SPPARC
ARCHITECTURE

Job Title 1602 - 182_184 High Holborn		Client Covent Garden Investment S.A.R.L
Drawing Title PROPOSED SECTION 01		Drawing Number & Revision HH-P-26-MF-01-01_P4
Scale (at A0) 1 : 100@A1	Date Amended 29.03.2017	Amended By GK
Checked Checker	Date Created	Drawn By Author

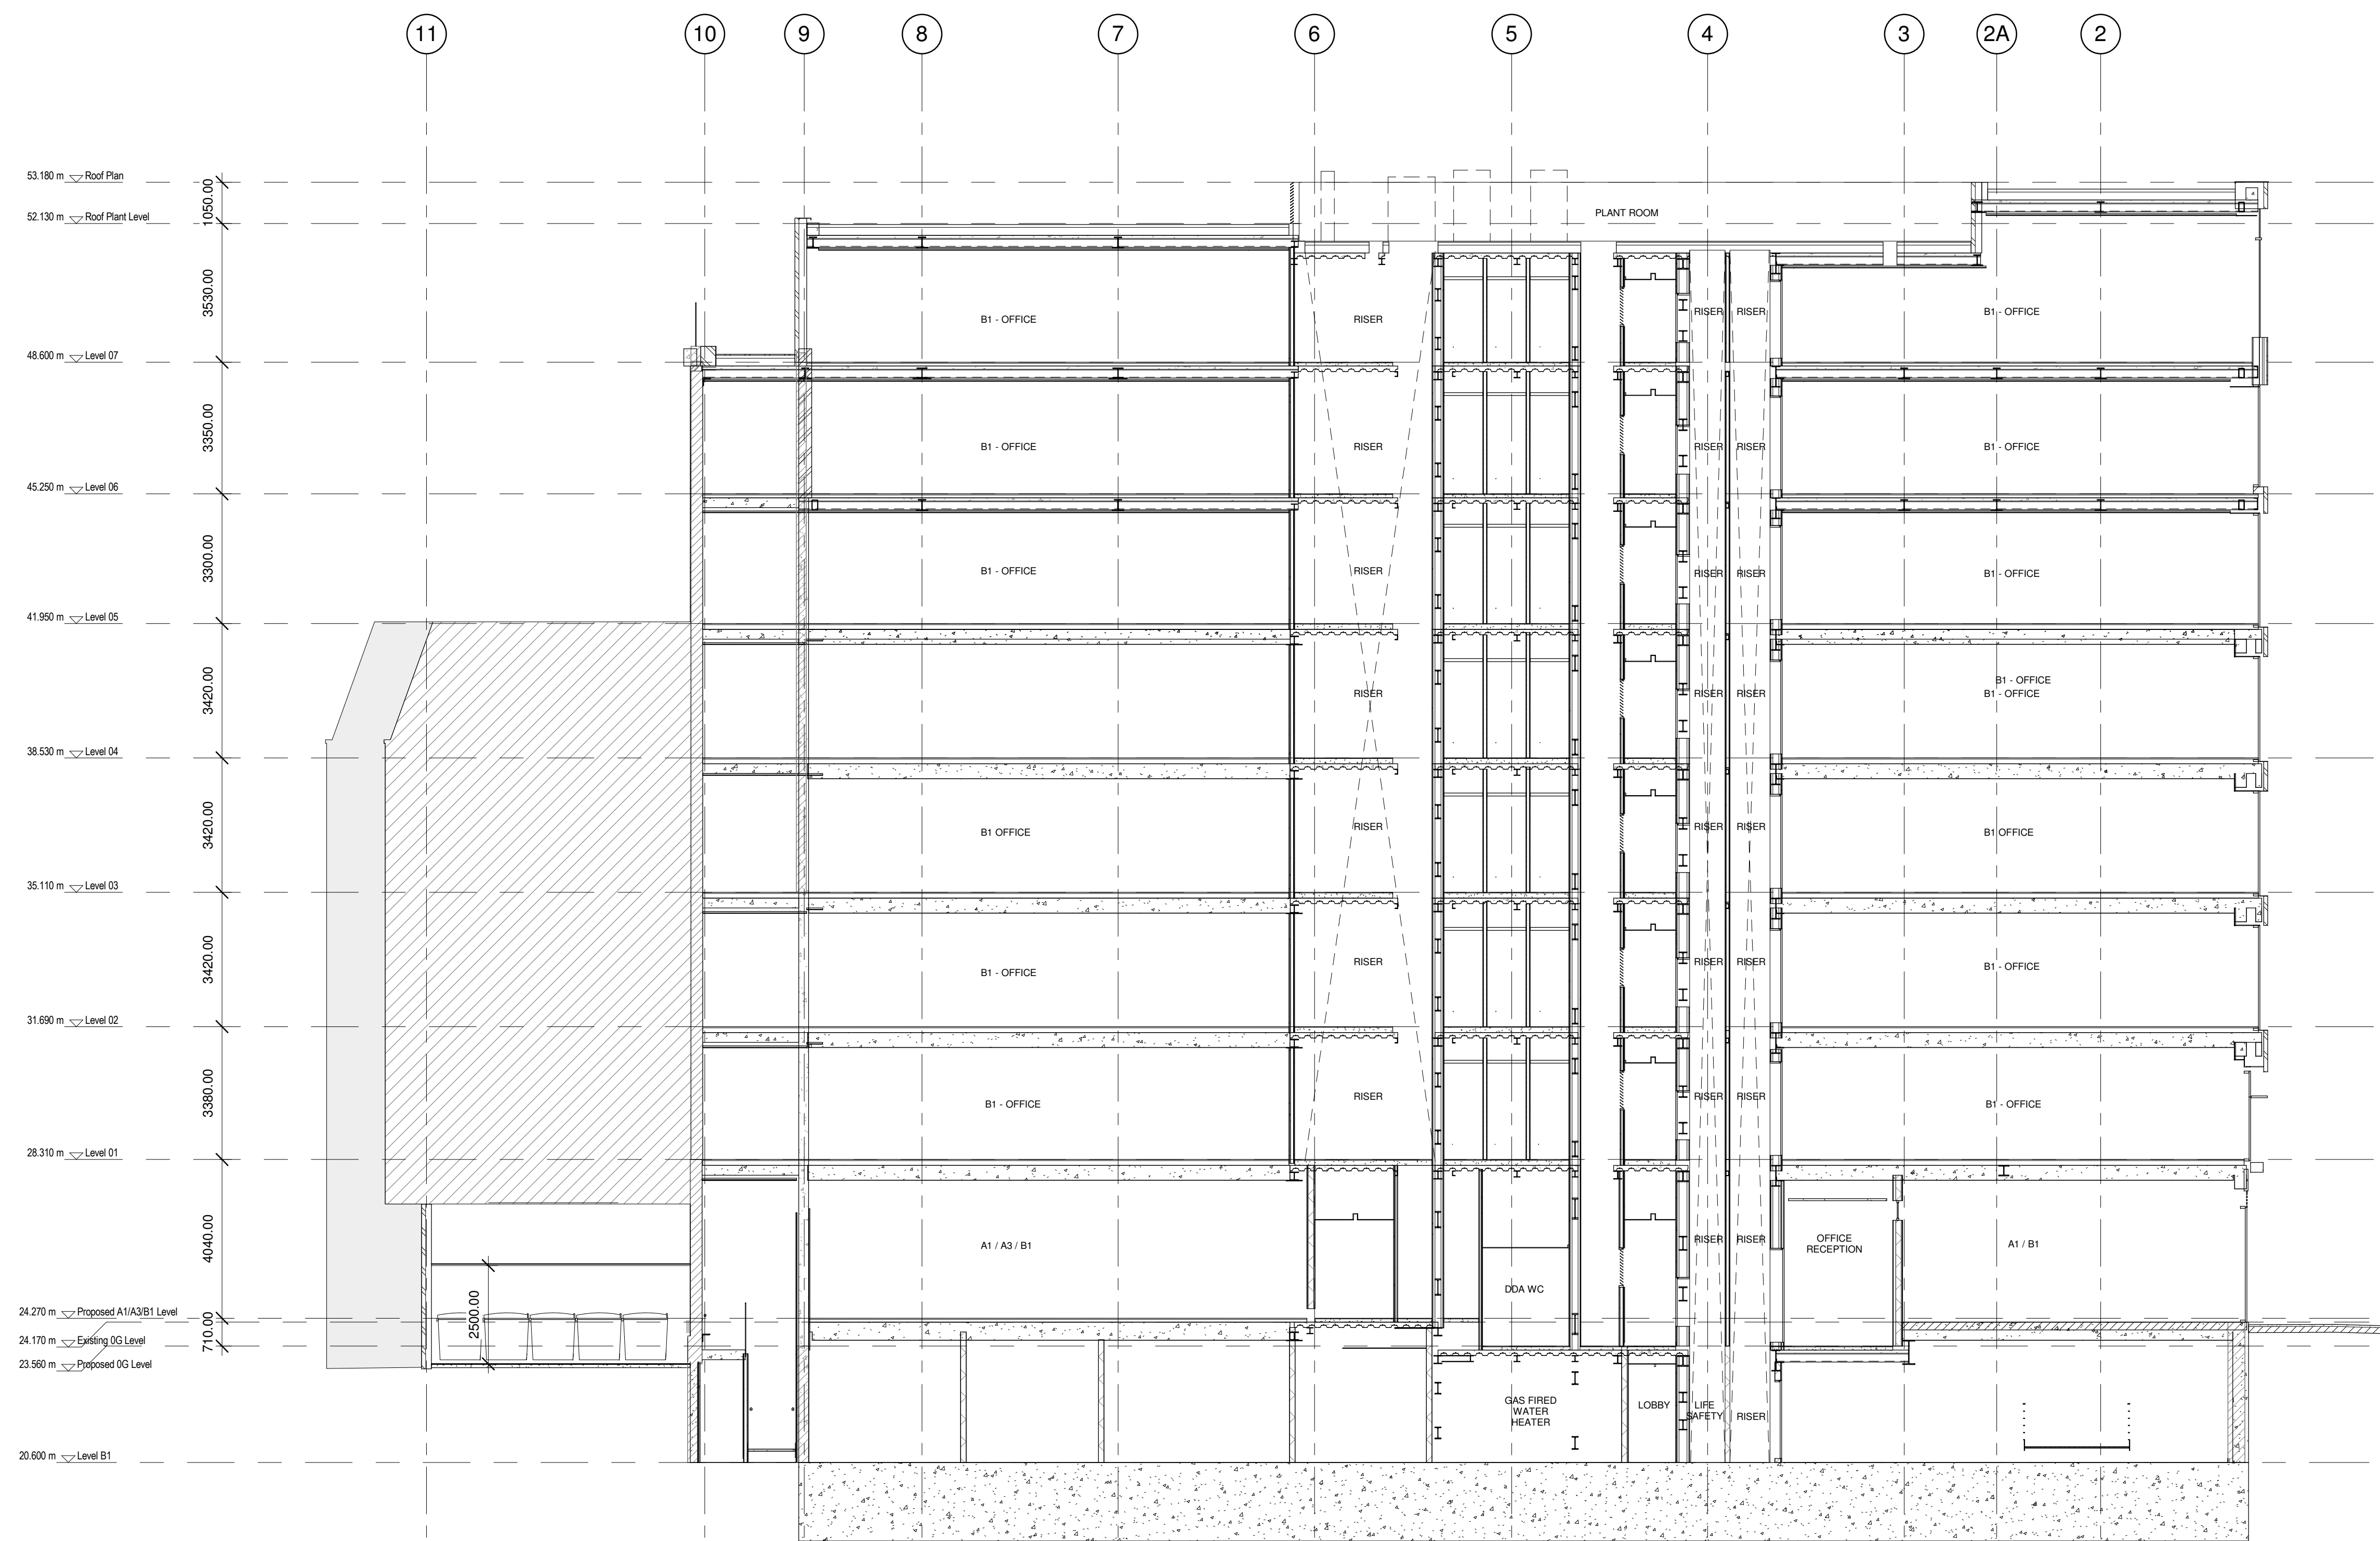
- CHANGES:**
- Roof plant equipment sits 300mm higher than plant enclosure.
 - There is an increased height on levels 6, 7 and Roof Plant in order to accommodate higher clear ceiling heights. Level 6 (FFL) has been increased by 150mm, level 7 (FFL) by 300mm and the roof plant level by 450mm-which is the total increase of the mass in terms of height. The top roof level has remained intact.
